To : Contracted AMO 145
CC : GAM Accountable Manager, GAM Quality Assurance Manager
From : Continuing Airworthiness Manager, GAM
Subject : **9M-PMA Floatation Gas Bottle Pressure Limits Placard Reference**

AW139 9M-PMA S/N 31807

Figure 2-4 Flotation Gas Bottle Pressure Limits
P/N 3G9560F00212 (Aerazur)

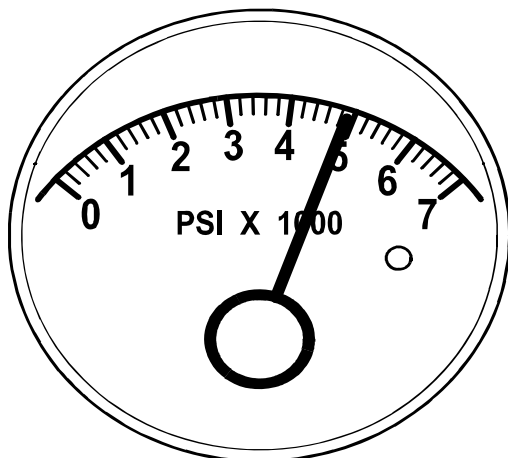
Gas Bottle Pressure Limits placards fitted on the float cover have been removed due to incorrect placard model fitted. Previously, placards fitted on the aircraft is for Aerosekur float model, however the correct placards should be as per AW139 RFM Supplement 9, Page S9-6F, Figure 2-4 as the aircraft is installed with Aerazur float model.

This notice is issued as a temporary instruction for contracted AMO maintaining AW139 9M-PMA S/N 31807 to use graph on the AW139 RFM Supplement 9, Page S9-6F, Figure 2-4 latest revision for checking the pressure of the float gas bottle until the new ordered placards arrived and installed.

- a) Contracted AMO 145
To use AW139 RFM Supplement 9, Page S9-6F, Figure 2-4 as attached or latest revision as reference to check the pressure of the float gas bottle when fitted on the 9M-PMA S/N 31807 aircraft
